WOLLONGONG COAL

RUSSELL VALE COLLIERY REVISED UNDERGROUND EXPANSION PROJECT

Submissions Report – Part A

November 2019

FIGURE 5.2

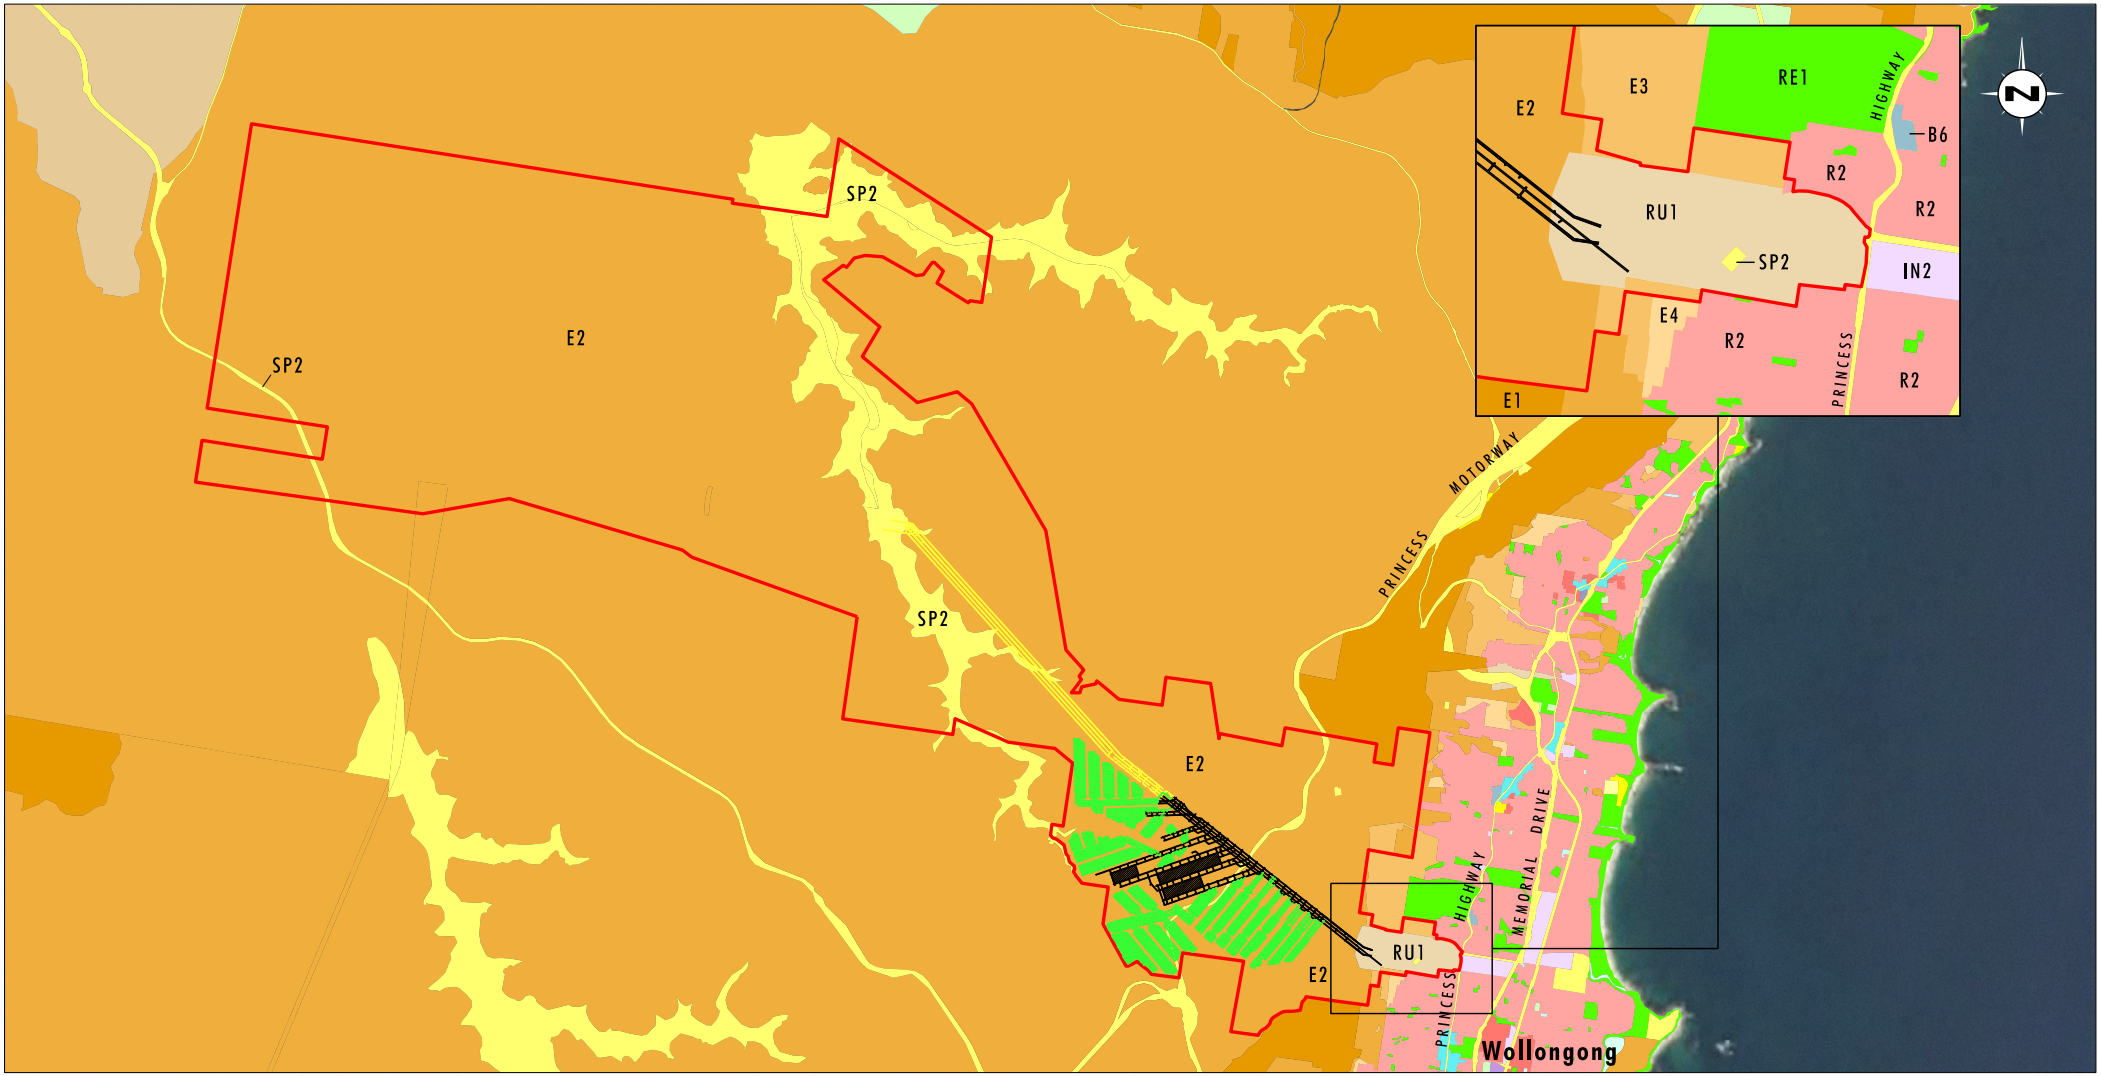
'Relevant land zonings under each of the LEPs are shown in Figure 3.1. Zoning map Page 33 shows zoning of land around the mine site. It fails to show any residential west of Princes Hwy. It doesn't show the WCC LEP environmental zonings along the escarpment. The map is very misleading.'

As identified in a community submission, there was an error in Figure 3.1 of the Revised Preferred Project Report resulting in the zoning being displayed incorrectly surrounding the Russell Vale Colliery Pit Top Facility. An updated zoning map is provided as **Figure 5.2**.

Despite the issue with Figure 3.1 of the Revised Preferred Project Report, all relevant assessments considered the correct zoning and land uses surrounding the Pit Top, this being primarily residential. There is no change to assessment outcomes from the Revised Preferred Project Report.

Figure 1. Russell Vale – Proposed Mine Plan and Production Schedule
(source: Wollongong Coal, WLC4111_09)

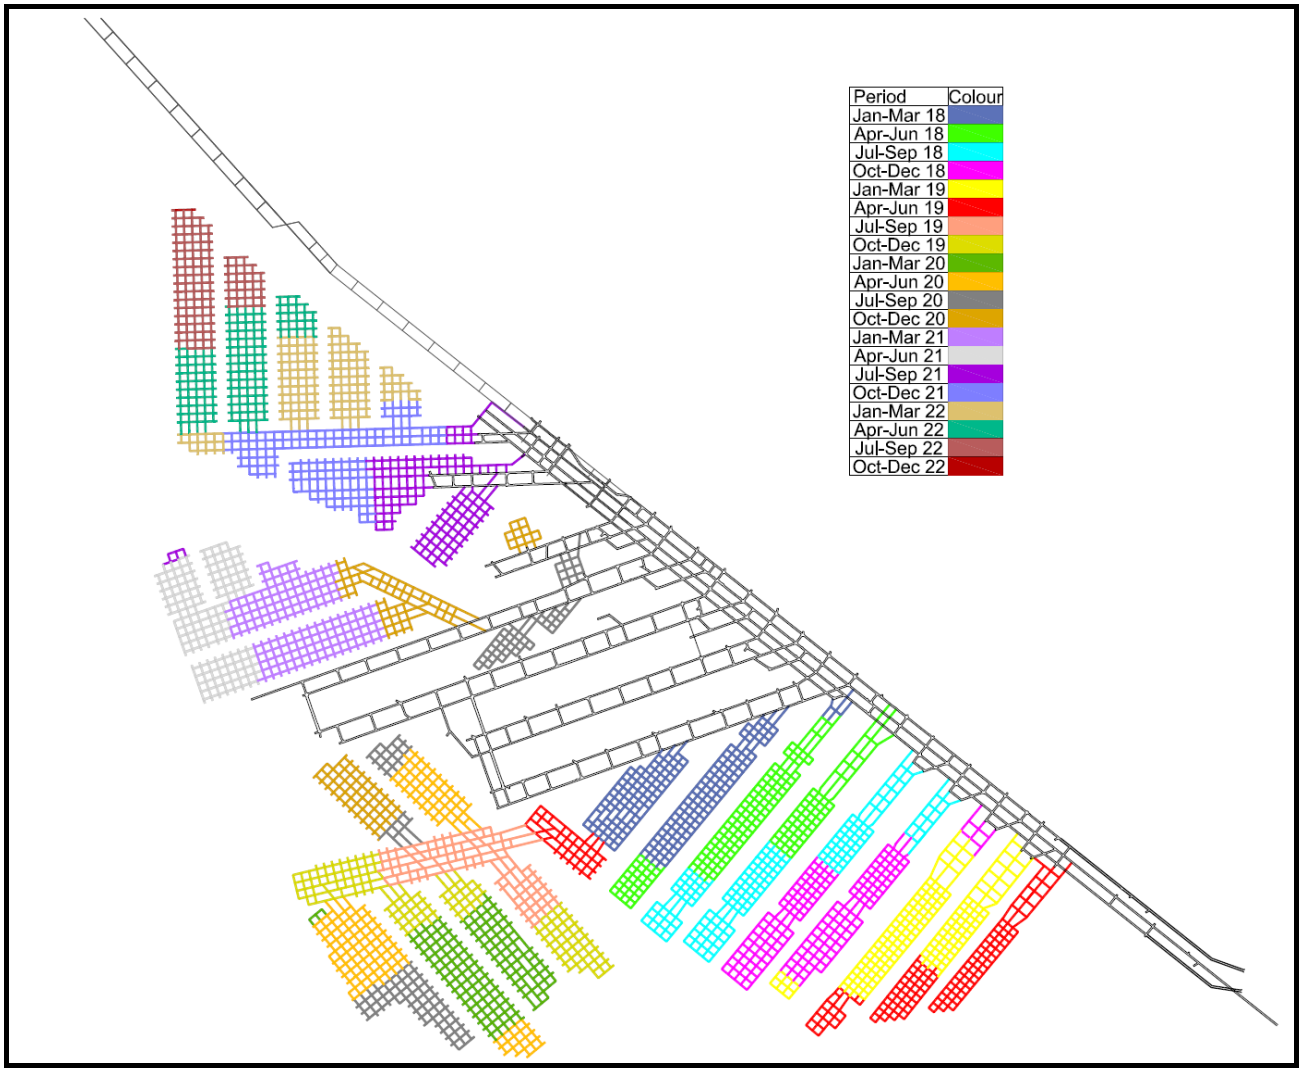
Figure 1 is a copy of the proposed mine plan as depicted in the updated Yearly Production drawing provided. This plan also shows the previously mined longwall panels in the Wongawilli Seam – LW4, LW5 and LW6.

Figure 4. Depth to floor of Wongawilli Seam
(source: SCT Report UMW4609, 2019)

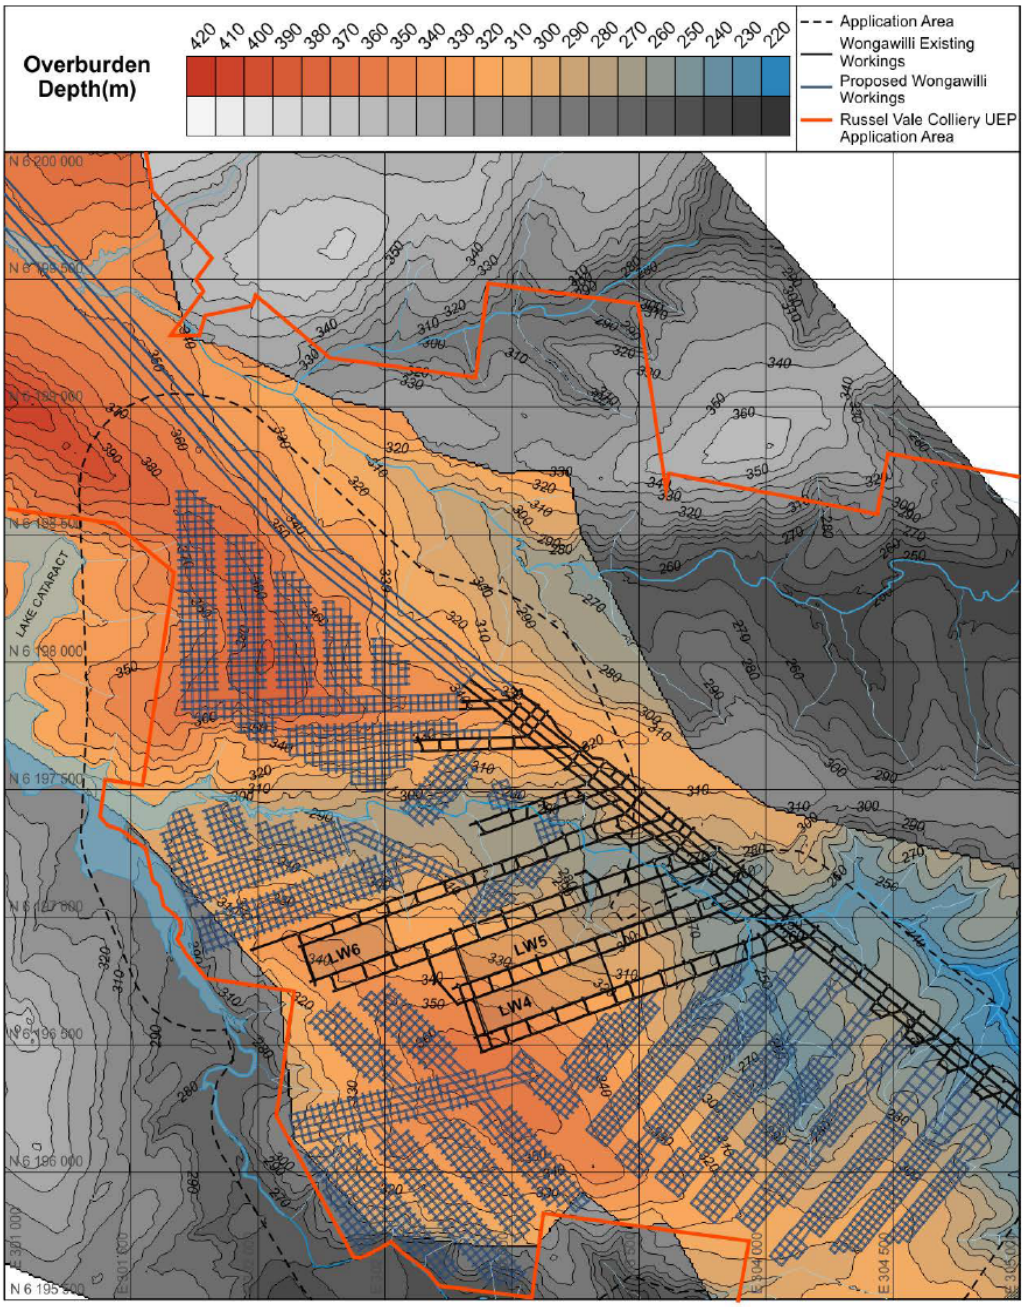
There is no reference here to depths, although this is provided by reference to contours, as shown in Figure 4 above.

Figure 5. Existing mine workings in all three seams, plus proposed Wongawilli Seam workings
(source: SCT Report UMW4609, 2019)

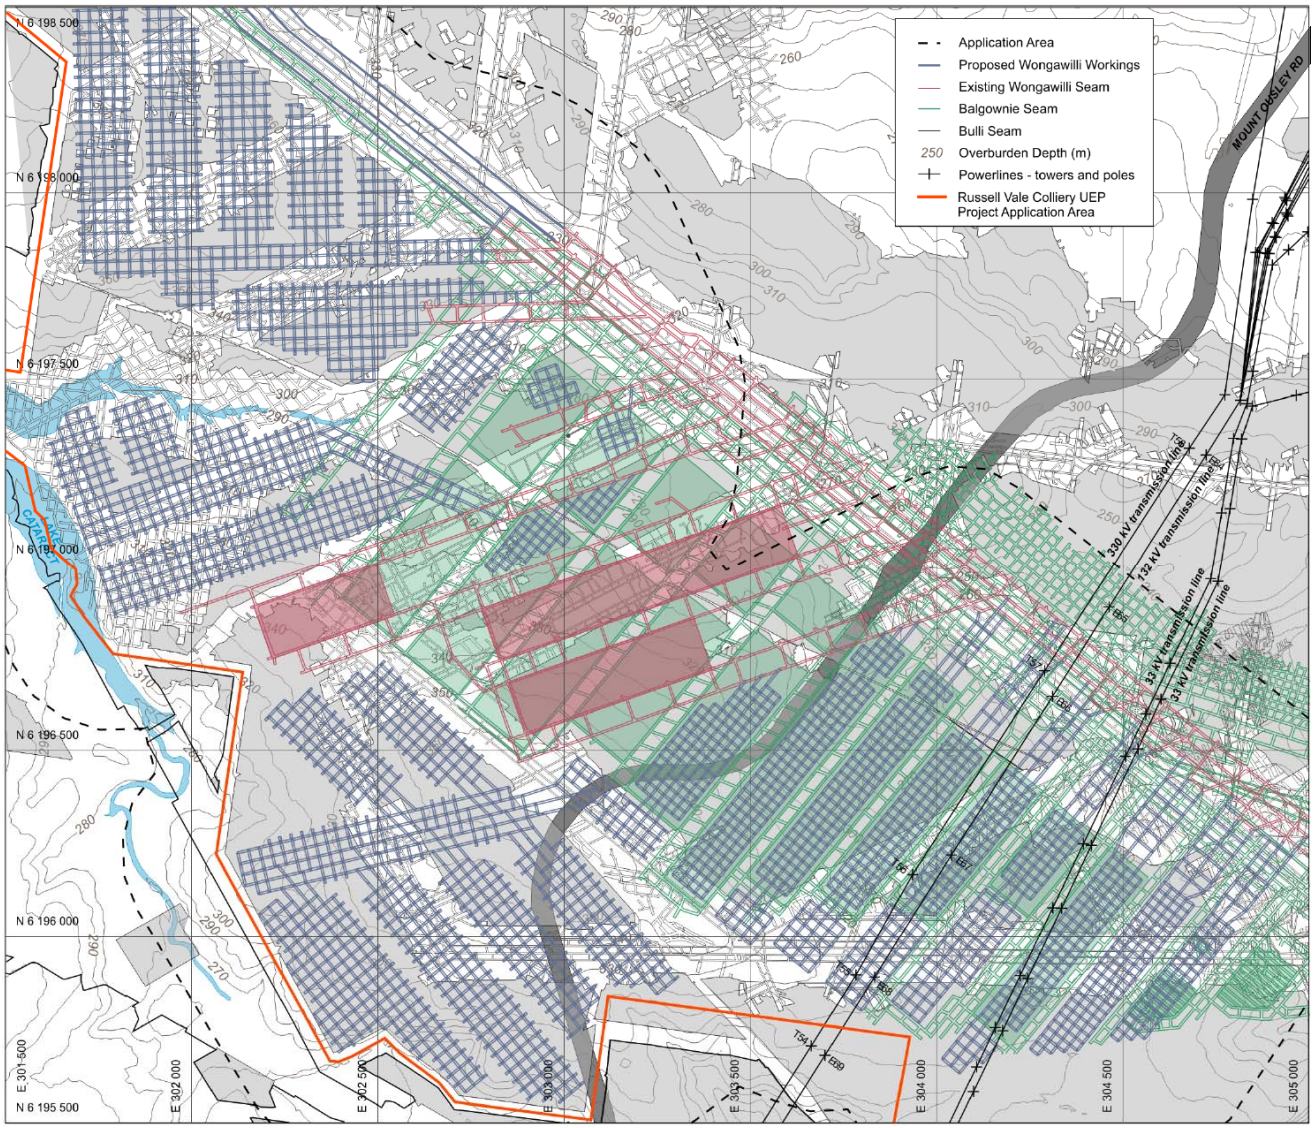
4. P18 (Previous Mining) – The plan showing all previous mining in the three seams has been reproduced as Figure 5 above. SCT has noted the design feature of aligning proposed Wongawilli Seam panels directly beneath the goaf areas of previous Balgownie Seam longwall panels. This is considered good practice for two reasons – firstly, as stated in the Report, it avoids any under-mining of the Balgownie chain pillars that might threaten their load-carrying capacity for the overlying overburden. Secondly, it provides a degree of protection for the loading applied to the pillars in the proposed new Wongawilli Seam panels. This is good practice, although there is a possibility that some of the pillars on the edges of the new panels may see some excess load due to the expanding footprint of load beneath the overlying chain pillars. This is likely to only result in localised issues, if any, rather than any serious regional instability.

Figure 7. Copy of SCT Figure 15 showing area of potentially unstable Bulli Seam pillars
(source: SCT Report UMW4609, 2019)

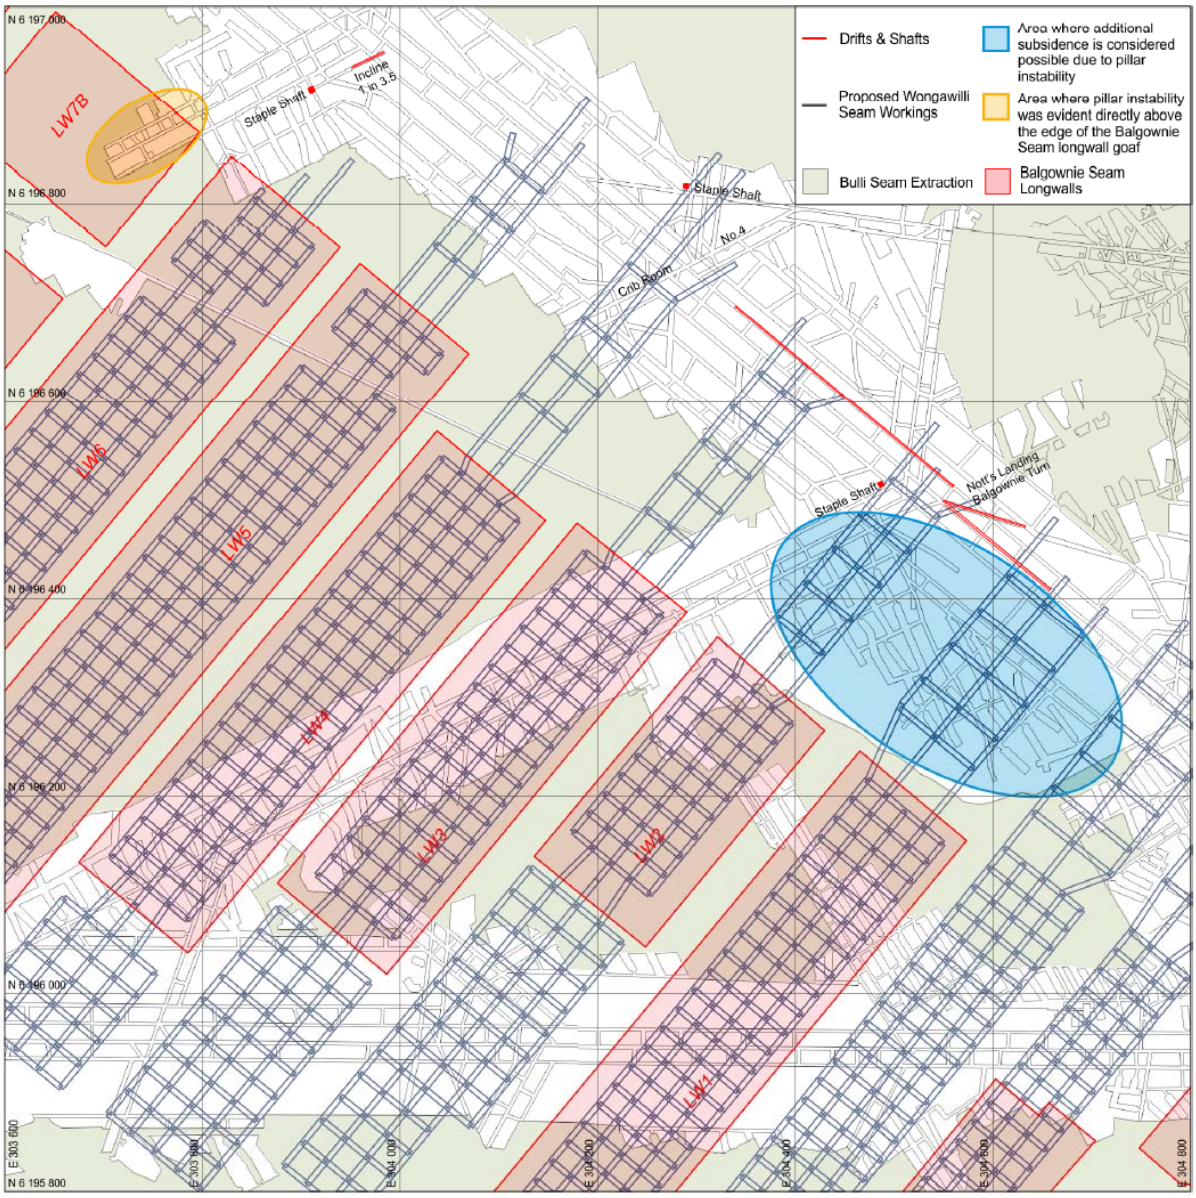
It is not intended to provide a review of the Appendices which cover previous work done in reviewing mining and subsidence impacts associated with previous mining activity. It is noted, however, that Figure 15 in the Appendices shows an area of potentially unstable small pillars in the Bulli Seam. It is unclear, though likely, that this is the area of pillars referred to on multiple occasions by SCT in the Report. A copy of Figure 15 is reproduced below, for information, as Figure 7.

- Section 3.6, comment 5 – A copy of the previous Figure 15 from the Appendices has now been brought forward into the main report as Figure 13, to indicate one such location of marginally
